Westfield Penrith Access Report 1

This Access Australia (AA) Access Report relates to instructions and documents received to date from Scentre Group / Westfield regarding Westfield Penrith Shopping Centre, Penrith NSW.

Riley & Henry Sts intersection

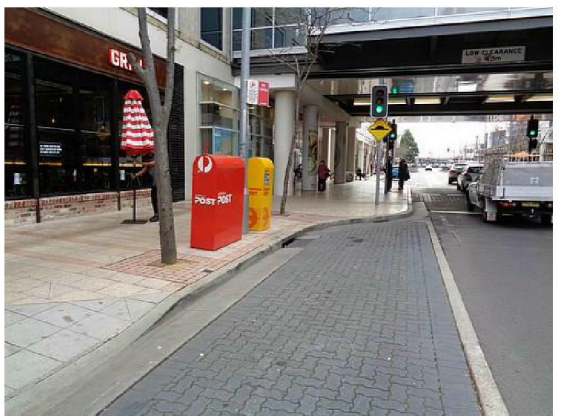
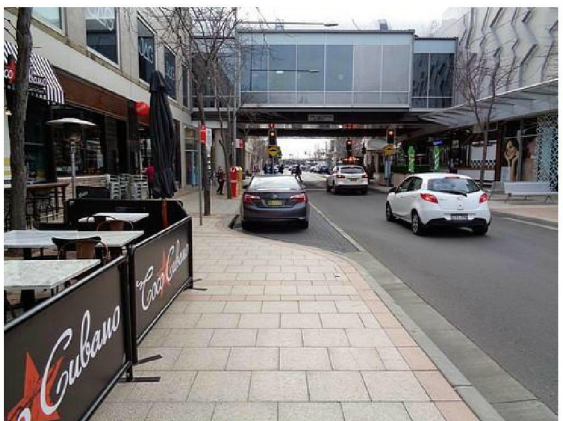
The Riley St south intersection at Henry St has signalised crossings, kerb ramps and generally complying tactile indicators in the direction of travel.

Penrith Plaza / Riley St crossing

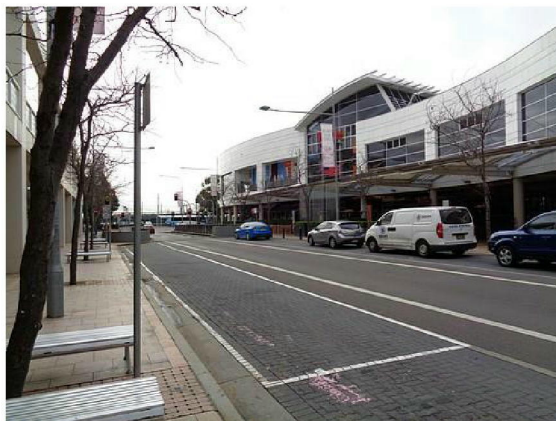
A raised pedestrian crossing centrally in Riley St links Penrith Plaza east and west sections, with signalised crossing and bollards providing minimum 1500± wide POTs.

Cobble stone paving at crossing approach is not accessible.

Riley St NE section – taxi area

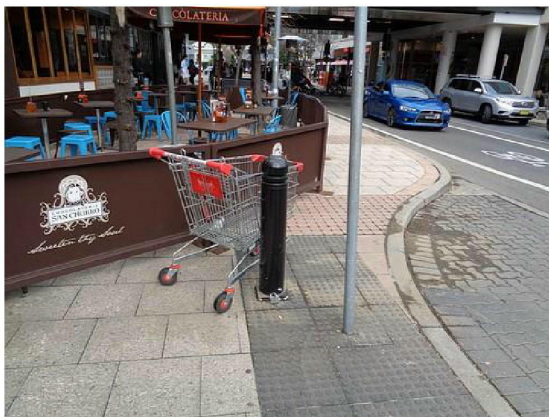
Pedestrian POT is restricted to 800± between bollards and other obstructions at the south end of the taxi zone.

Riley St NE – paths of travel

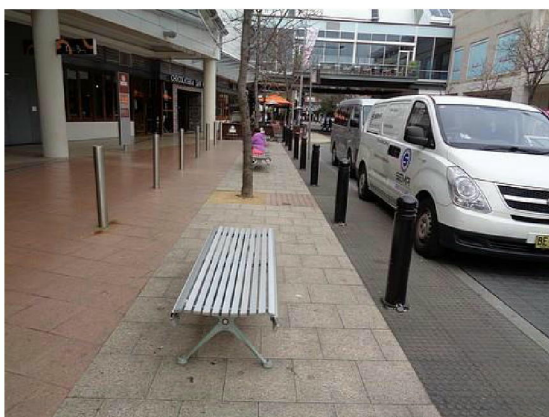
Main SE pedestrian footpaths are located adjacent to facades with 2.5m± to 3m± POTs generally. Paving and seating is in the direction of travel.
